REQUEST FOR COUNCIL ACTION

AGENDA SECTION: PUBLIC HEARINGS	ORIGINATING DEPT: PLANNING	ITEM NO. E-6
ITEM DESCRIPTION: Land Subdivision Permit (Preliminary Plat) #03-09 to be known as North Park Fourteenth Subdivision by Leslie A. Lurken. The Applicant is proposing to subdivide approximately 11.42 acres of land into 42 lots for single family development and one Outlot. The Plat also proposes to dedicate new public roadways. The applicant is also requesting approval of a Substantial Land Alteration to permit site grading that will modify grades by more than 10 feet on portions of the property. The property is located west of Hillsboro Drive NW and east of Fairway Drive NW.		PREPARED BY: Theresa Fogarty, Planner

RE: Land Subdivision Permit (Preliminary Plat) #03-09 to be known as North Park Fourteenth Subdivision by Leslie A. Lurken. The Applicant is proposing to subdivide approximately 11.42 acres of land into 42 lots for single family development and one Outlot. The Plat also proposes to dedicate new public roadways. The applicant is also requesting approval of a Substantial Land Alteration to permit site grading that will modify grades by more than 10 feet on portions of the prope

PRELIMINARY PLAT

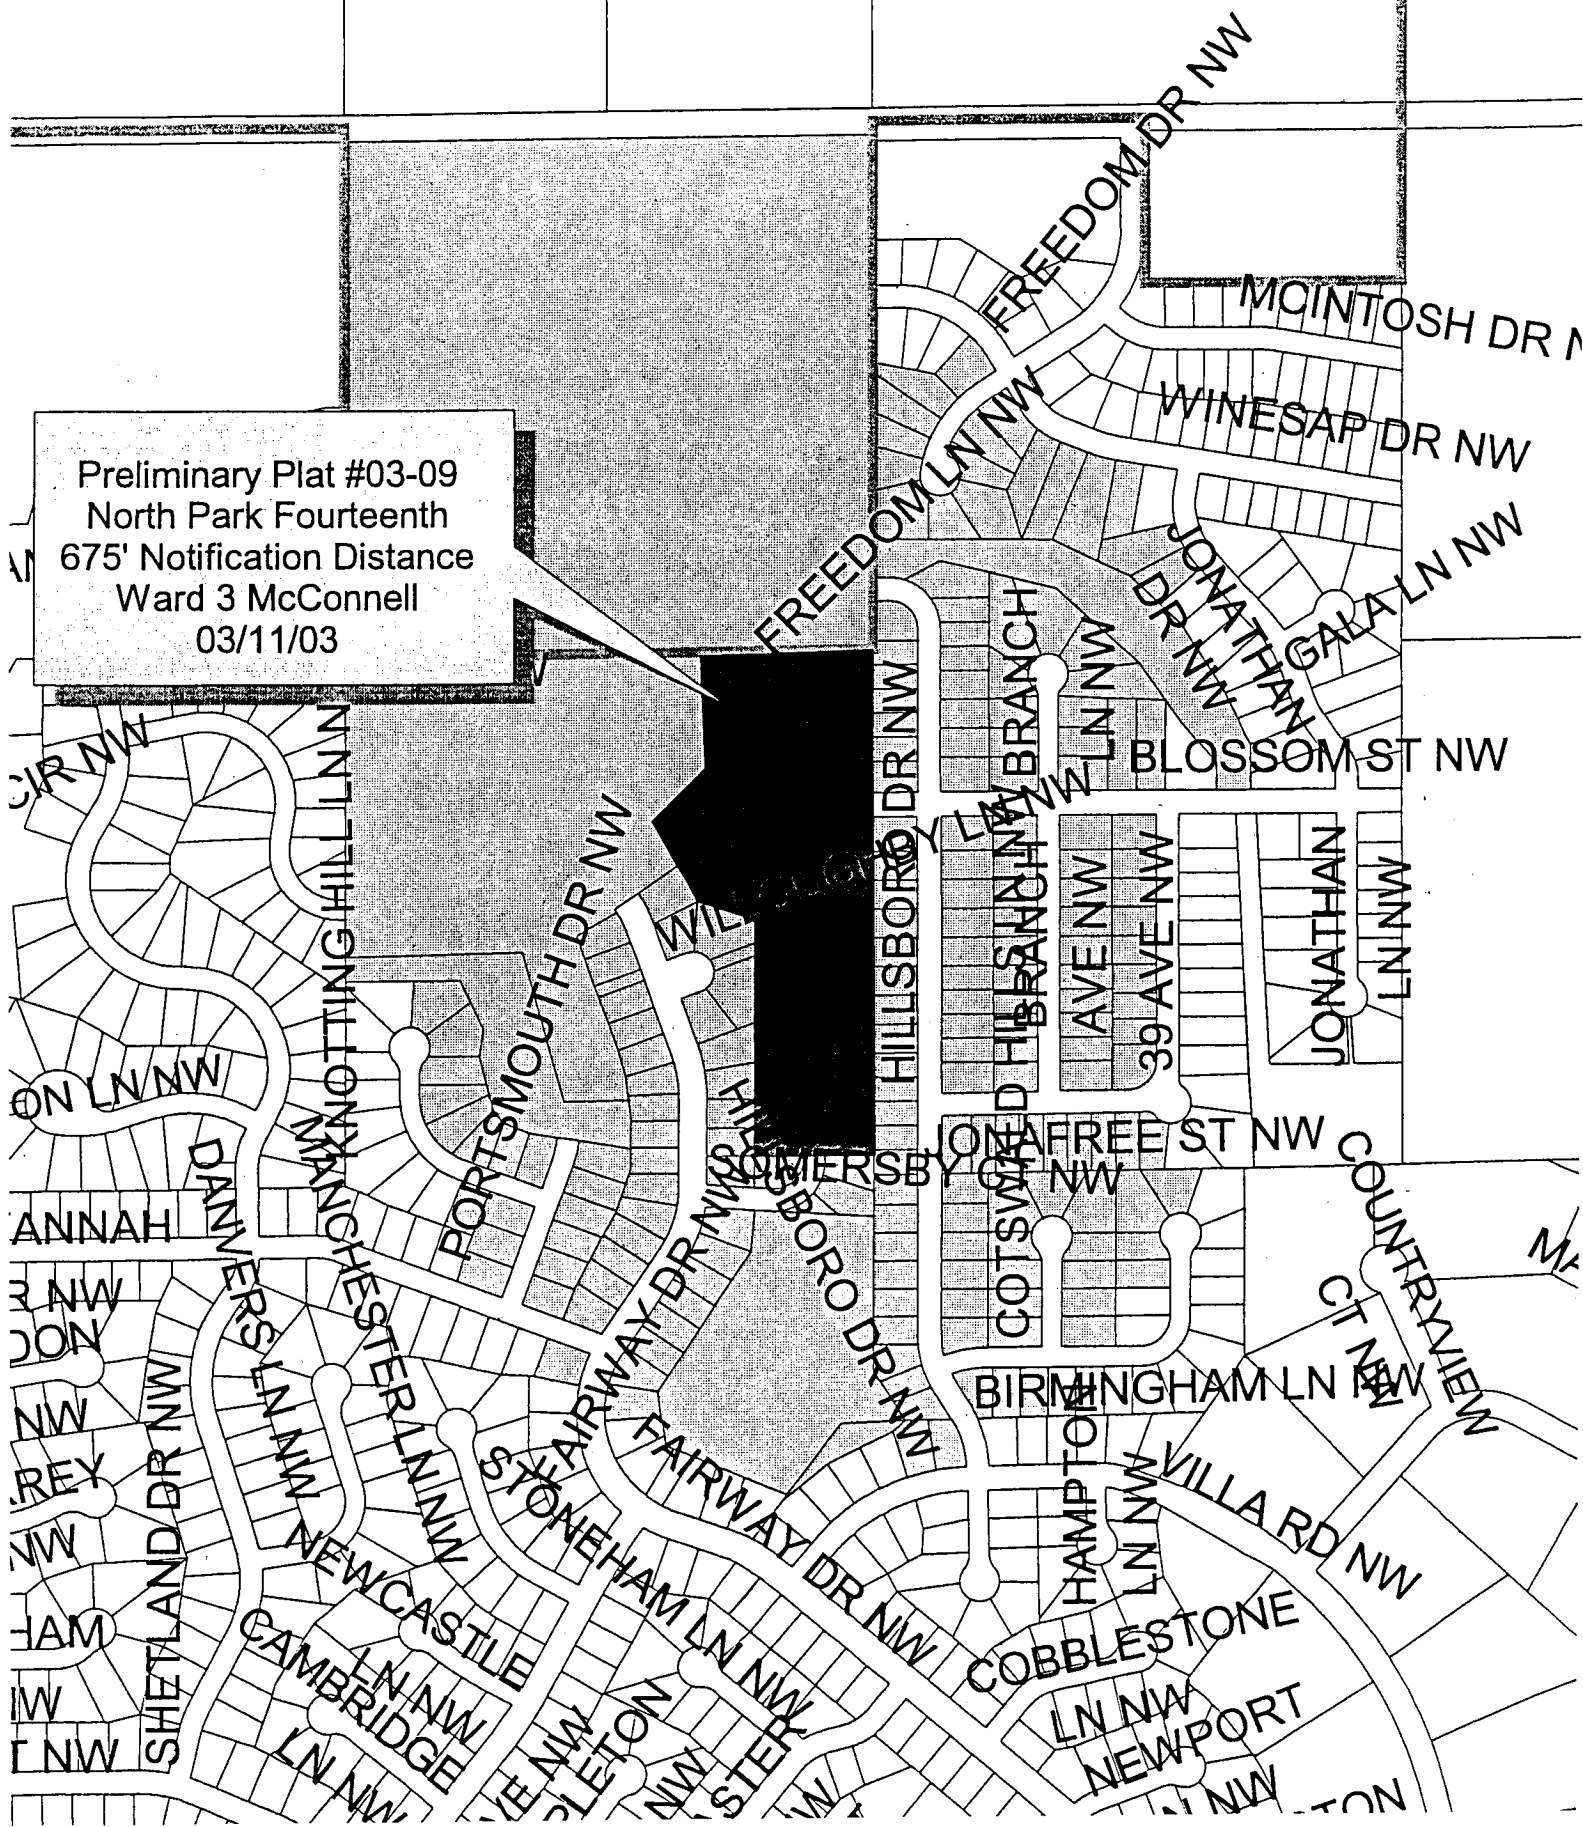
The first roadway named "Somersby Court NW" is designed with a 56' right-of-way. This roadway is indicated less than 36 feet and will require "No Parking" signage along one side of the street.

The second 56' roadway named "Street" that goes north from the intersection of Blossom Street NW and Somersby Court NW and then takes a 90 degree turn to the west needs to be given a completed designation. This roadway needs to be illustrated as "Somersby Court NW". This roadway is indicated less than 36 feet and will require "No Parking" signage along one side of the street.

The third roadway named "Blossom" is designed with a 60' right-of-way. This roadway needs to be illustrated as "Blossom Street NW".

The fourth roadway labeled "Street NW" is designed with a 50' right-of-way ending in a cul-de-sac with a 51' radius. This roadway will need to be changed to "Blossom Lane NW". The cul-de-sac is indicated less than 96 feet in diameter and the roadway is indicated as less than 36 feet. Therefore cul-de-sac and roadway shall be marked "No Parking".

Construction of a temporary turn-around and dedication of an applicable temporary easement is required at the westerly extent of the street abutting Lot 1, Block 1 and Lot 1, Block 4.

The preliminary Grading Plan indicates a temporary sedimentation basin within the ROW of Blossom Street NW (between Lot 1, Block 2 & Lot 9, Block 1), and temporary sedimentation basin within the ROW of Somersby Court NW (between Lot 7, Block 1 & Lot 12, Block 2). These proposed sediment basins will not be permitted in the ROW. The Owner will be required to construct and maintain any required temporary sediment basin(s) on individual lot(s) within the subdivision. All storm water from this plat shall be directed into the temporary sediment basin(s) until such time all other lots are developed or sodded.

1. The Plat shall be revised:

- a. **Identifying the roadway named "Street" that goes north from the intersection of Blossom Street NW and Somersby Court NW and then takes a 90 degree turn to the west as "Somersby Court NW".**

- b. **Identifying the roadway named "Blossom" as "Blossom Street NW".**
- c. **Identifying the cul-de-sac roadway named "Street" as "Blossom Lane NW".**

3. **The Applicant shall dedicate Outlot 'A' to the City. In addition, the Applicant shall grade and establish turf prior to deeding to the City.**
4. **Grading and Drainage Plans shall be approved by the City Public Works Department prior to the submittal of the final plat. The preliminary Grading Plan indicates a temporary sedimentation basin within the ROW of Blossom Street NW (between Lot 1, Block 2 & Lot 9, Block 1), and temporary sedimentation basin within the ROW of Somersby Court NW (between Lots 7, Block 1 and Lot 12, Block 2). These proposed sediment basins are not permitted within the ROW. The Owner shall construct and maintain any required temporary sedimentation basin(s) on individual lot(s) within the subdivision. All storm water from this plat shall be directed to the temporary sediment basin(s) until such time all other lots are developed and sodded.**

5. **The Applicant shall construct a temporary turn-around and dedicate an applicable temporary easement at the westerly extent of the roadway abutting Lot 1, Block 1 and Lot 1, Block 4.**

6. **The cul-de-sac and roadway to be named "Blossom Lane NW" and the roadway named and to be named "Somersby Court NW, shall posted "No Parking" along one side of the roadway.**
